**SUBJECT:** NuScale Power, LLC Response to NRC Request for Additional Information No. 194 (eRAI No. 8884) on the NuScale Design Certification Application

**REFERENCE:** U.S. Nuclear Regulatory Commission, "Request for Additional Information No. 194 (eRAI No. 8884)," dated August 21, 2017

## Response to Request for Additional Information Docket No. 52-048

**eRAI No.:** 8884

Figure 2-15 Control rod drive shaft, in-core instrument guide tube, and supports

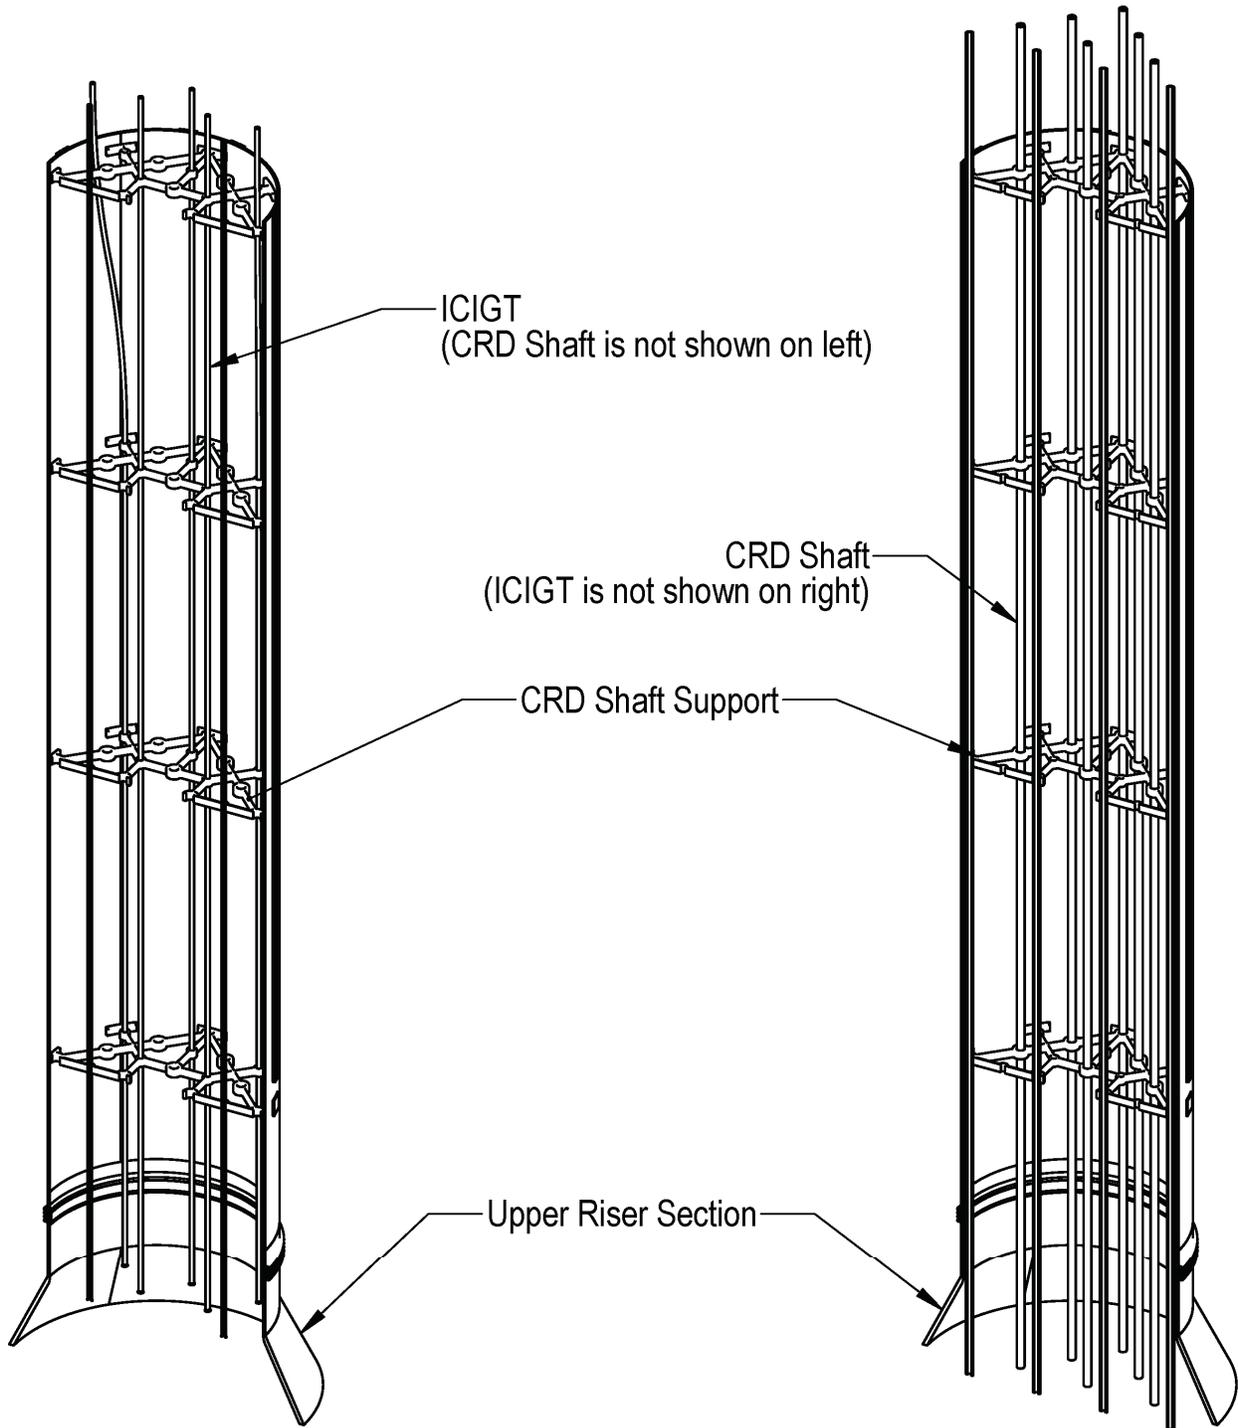
Figure 2-18 and Figure 2-22 of TR-0716-50439 Rev 0 have been updated per the response to RAI 8901 Question 03.09.05-8. Additionally, Figure 2-14 and Figure 2-16 of TR-0716-50439 Rev 0 have been revised to update the term 'CRDS' to 'CRD Shaft.'

FSAR Tier 2 Section 3.9.2.3 and technical report TR-0716-50439 Rev 0 Figure 2-14, Figure 2-16, Figure 2-18 and Figure 2-22 have been revised as described in the response above and as shown in the markup provided with this response.

Figure 5.4-6: Steam Generator Tube Support Bars and Cantilevers

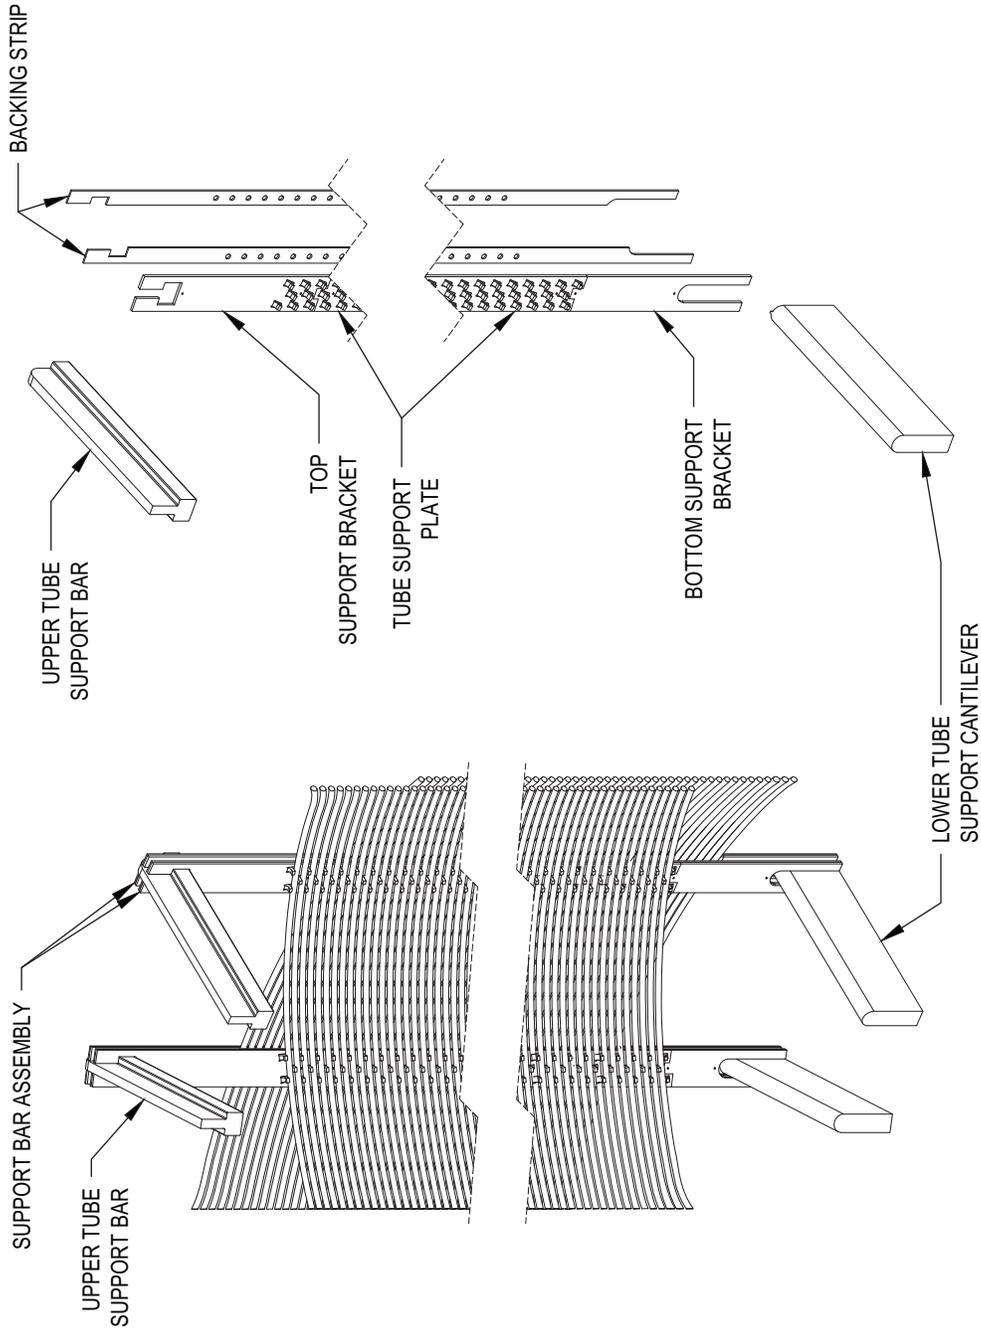
10 CFR 50, Appendix A, GDC 2 requires systems, structures, and components important to safety be designed to withstand appropriate combinations of the effects of normal and accident conditions with the effects of natural phenomena including earthquake. DCD Tier 2, Section 5.4.1 and TR-0716-50439-P, Rev, 0, “NuScale Comprehensive Vibration Assessment Program Technical Report” provide figures of the steam generator tubes and tube supports. The NRC staff needs additional information to understand the details of the tube support design. Therefore, the staff requests the applicant to provide sketches showing details of the steam generator tube supports including components such as tube support bracket, support backing strip. Provide a discussion of the clearance between components and identify these clearances on the sketches. Update the DCD or CVAP technical report to include the requested information.

FSAR Figure 5.4-6 has been updated to include a detailed view of a steam generator tube support. The figure includes labels for the tube support plates, the top support bracket, the bottom support bracket, and the backing strips.

FSAR Tier 2 Figure 5.4-6 and technical report TR-0716-50439 Section 2.3.2.1 have been revised as described in the response above and as shown in the markup provided with this response.
